Minute No. 604
Report – Standing Policy Committee on Property and Development – September 10, 2013

Item No. 3 Palliser Major Redevelopment Site Area Master Plan (North Kildonan Ward) File SP 2/2013

Title: Palliser Major Redevelopment Site Area Master Plan, SP 02/2013

45) **on Figure 14, which is the Land Use and Transportation Policy Map**

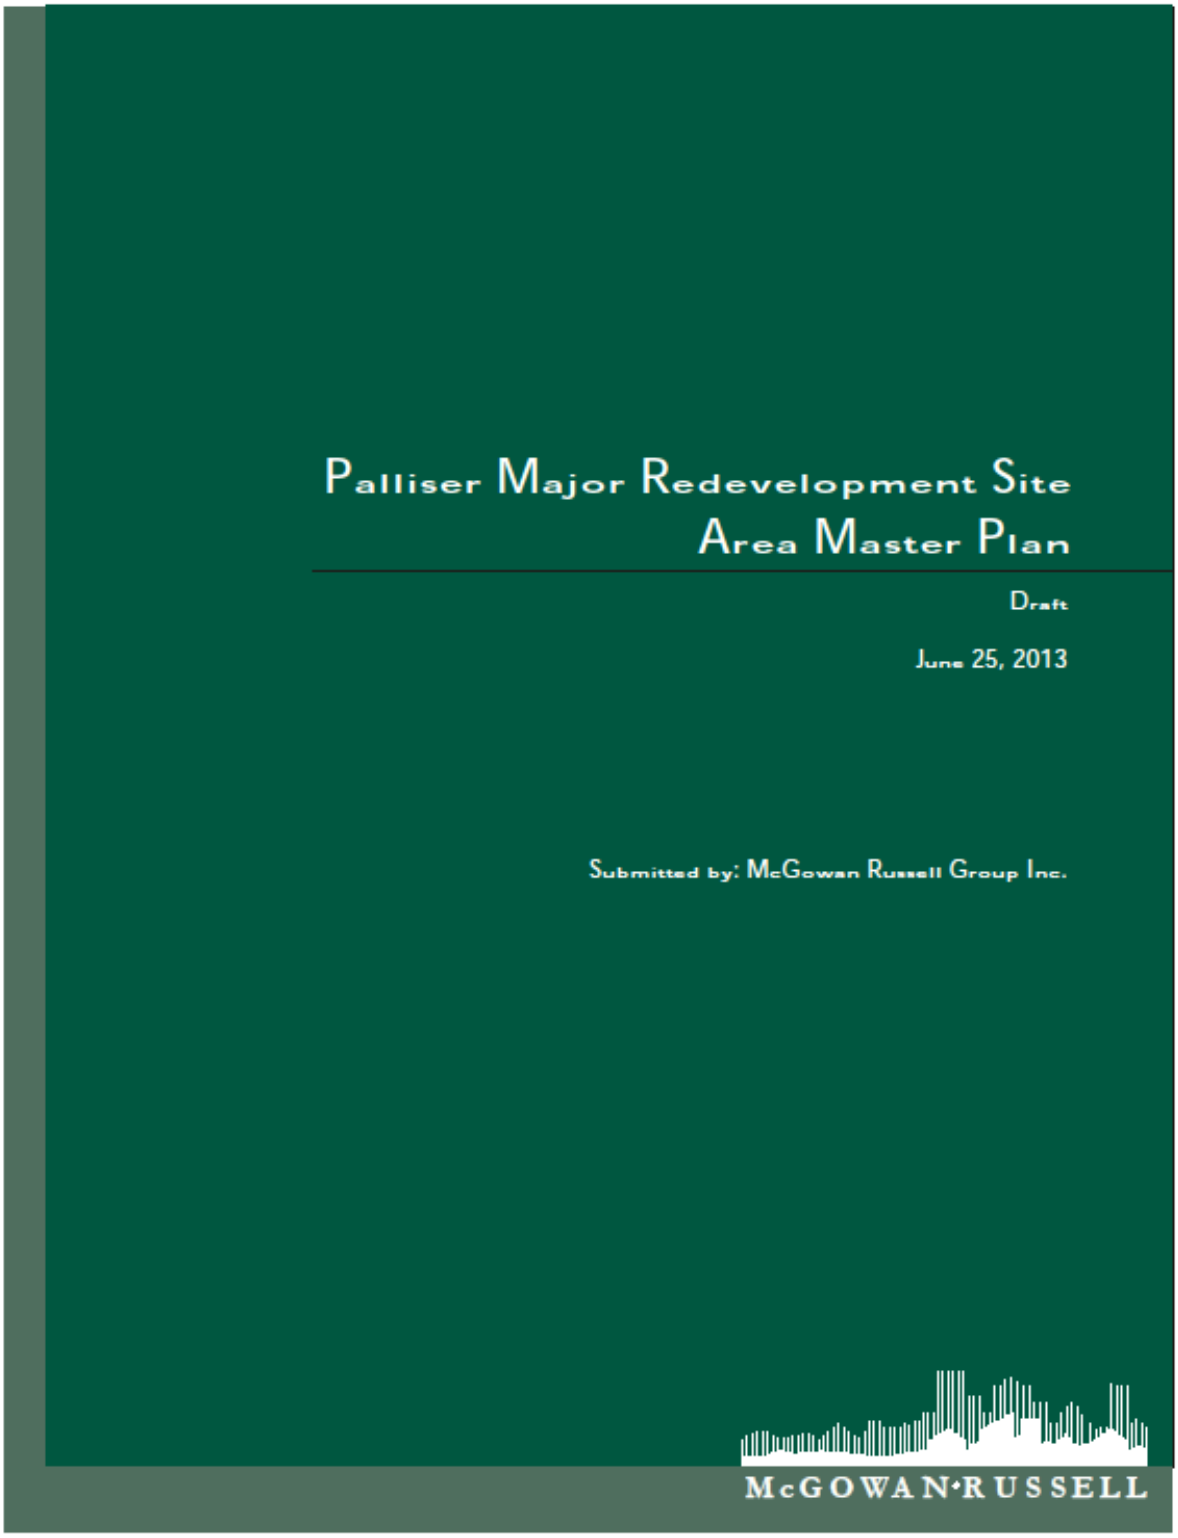
- **extend the green area indicating a landscaped buffer alongside Springfield Road west to Gateway Road,**
- **delete the view corridor on the map and in the legend,**
- add "see section" after the hyphens in the legend and add an "*" after the section references in the legend,
- below the legend, insert "* See also Sections C1, C2, C3, C7, C8 and C9." and
- after "landscaped buffer" in the legend insert " – see Subsection C3.2.4".

The recommended amendment in the first bullet, above, is ensure the Plan is consistent in establishing a buffer between development in the Palliser Major Redevelopment Site and the residential neighbourhood to the north.

The recommended bullet in the second bullet, above, is to remove an inconsistency in the plan, which is that the view corridor would not allow for the creation of a high-density, pedestrian-oriented environment along parts of Lexington Park and Gateway Road.
